The Columbia Planning Commission Development Review Committee will meet on Tuesday, February 7, 2023 at 10:00 AM in Conference Room A, basement level, City Hall,, to consider the following:

1. Case #22-0297 Request from Crunk Engineering for preliminary plat approval of the Waterford townhomes consisting of 75 units with five single family lots off [Pulaski Highway](#).

Below are our responses to comments received on November 8th, 2022. These comments along with a revised site plan was resubmitted November 18th, 2022, however, due to not being able to obtain the easement from the adjacent property owner, the site has been revised to ensure no grading and therefore no easement is required. The comments that were previously addressed have been provided below and have been updated based on this new site layout. We believe we have satisfied all comments, but if you have additional concerns or questions, please do not hesitate to contact us.

C5.3
TYPICAL LOT
LAYOUT

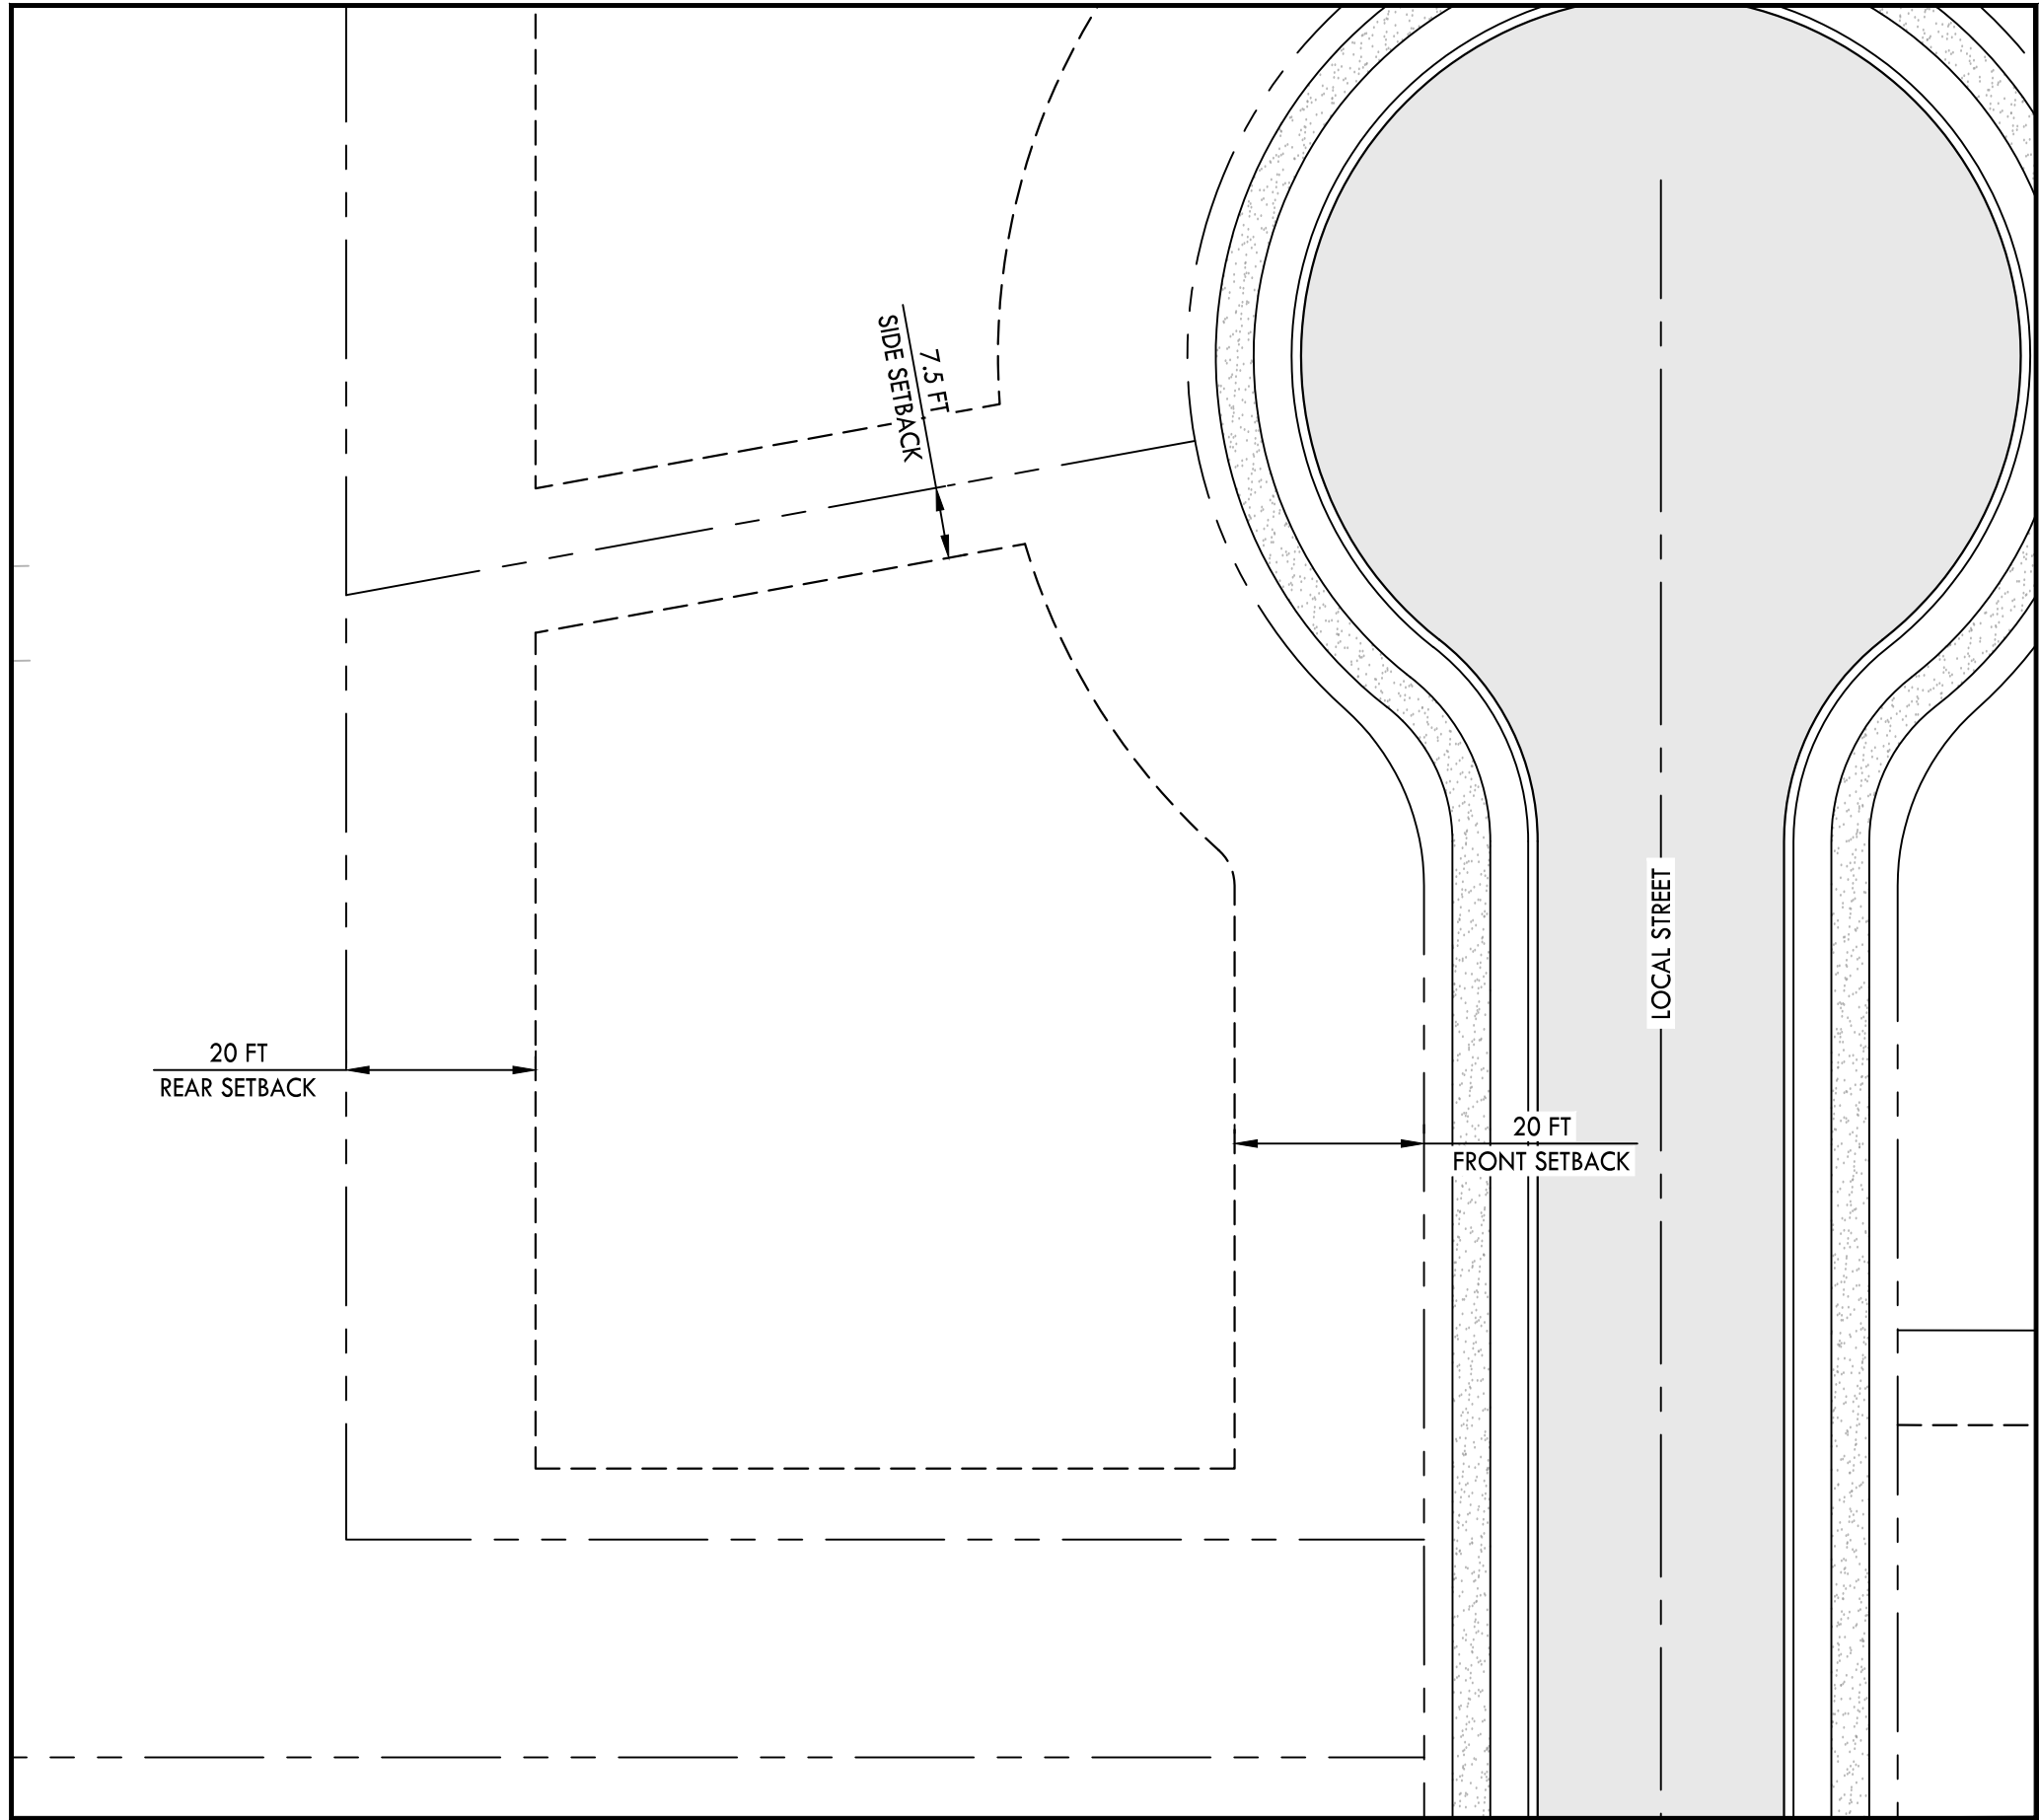
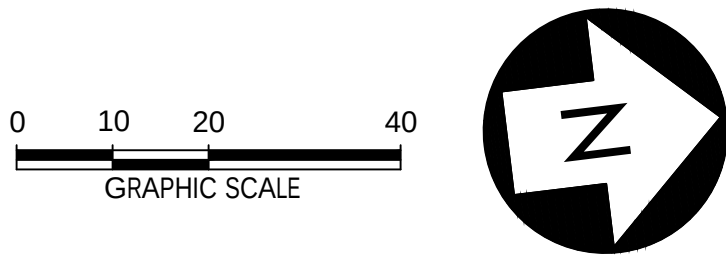
13. Show typical lot layout

17. Show townhome typical lot layout

Response: A typical lot layout has been provided for both the townhomes and the single family lots.

Response: Both the Townhome and Single-Family Typical Layout are shown on sheet C5.3

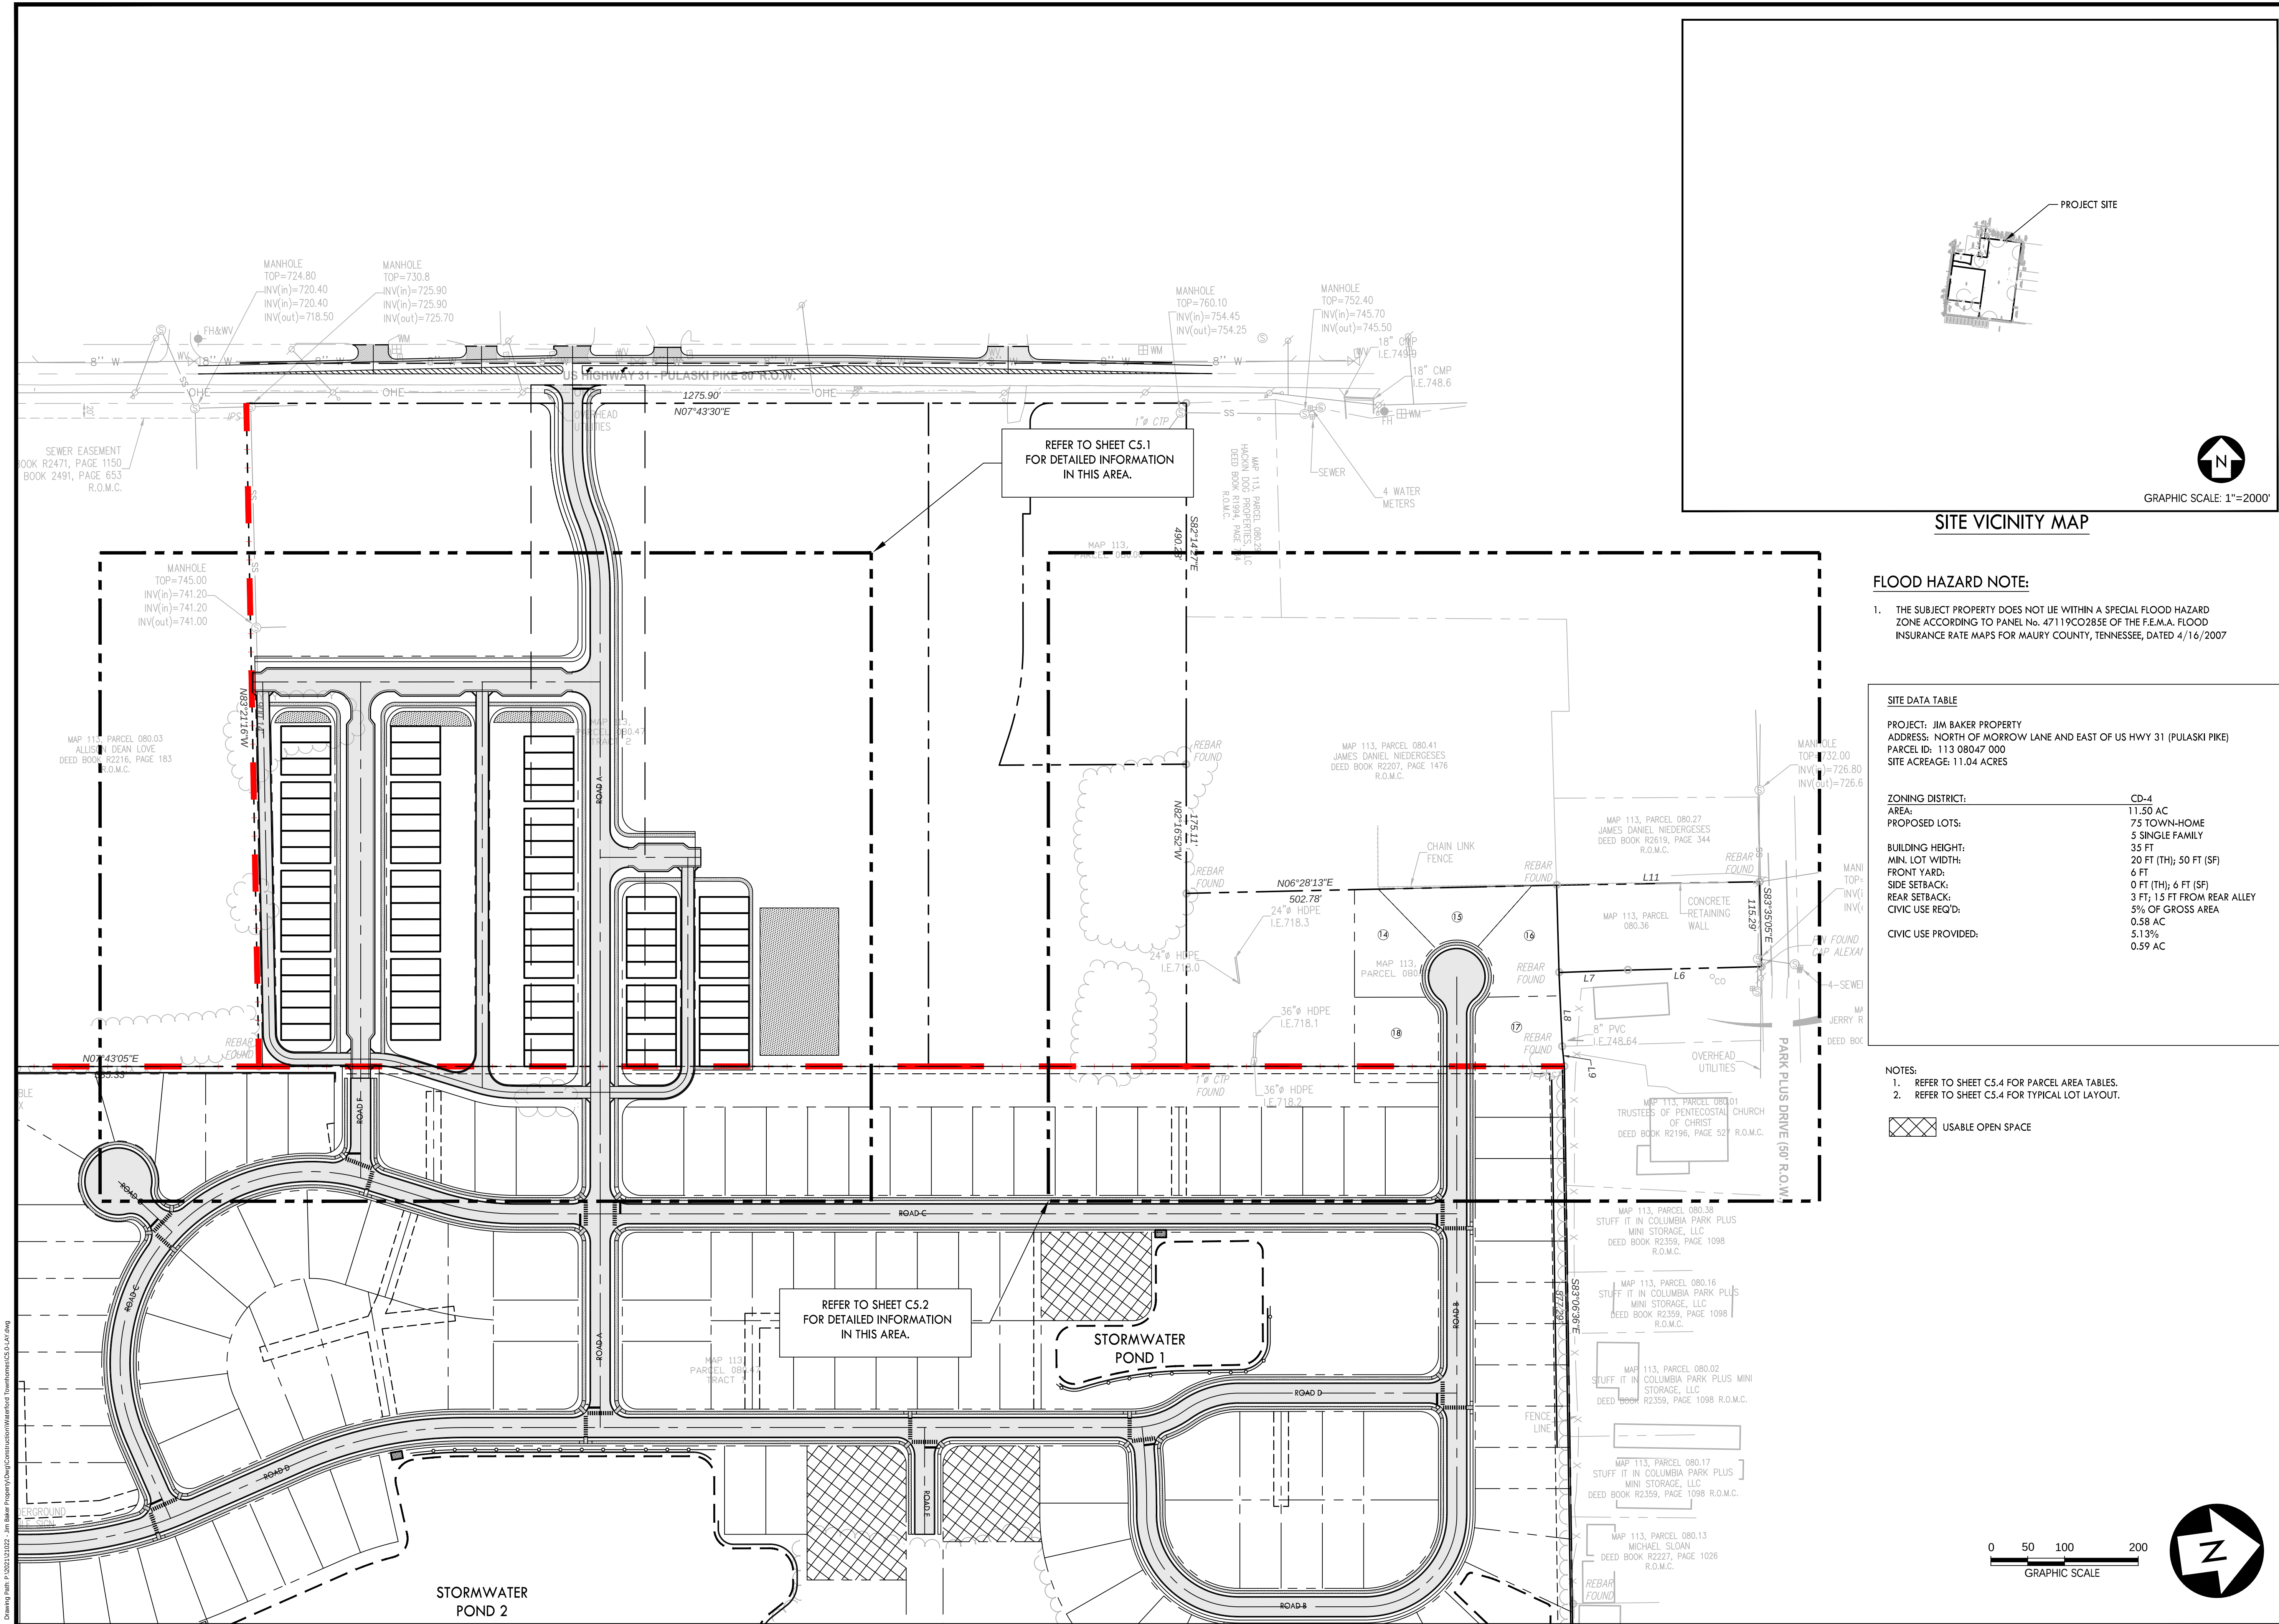
8. Show development plan with Civic Space radius, tree canopy retention, gardens will need to enfront buildings or to the rear of buildings with a fence detail and watering locations. Playground will need examples of structures to be installed.

9. Show commercial area in relation to the frontage of residential 85% max residential.

25. Provide diagram and commitment letter for TIS improvements

Response: Civic Space Radius has been shown on the Overall Site Layout Plan, Sheet C5.0. Tree Canopy Retention has been shown on Sheet C5.4. The site layout has been revised and there is no longer civic space located along the north side of the site. The main civic space is shown along the southern property line. This civic space is shown to be a pocket park and enfronts Alleys C, D, and E. The Pocket Park is shown in more detail on sheet C5.1.

Response: A note has been added to the Overall Site Layout Plan listing the required commercial frontage.

Response: The 85%/15% frontage mix has been calculated and shown on the Overall Layout Sheet Site Data Table, Sheet C5.0.

Response: a callout and location of the offsite improvements have been shown on sheet C5.0
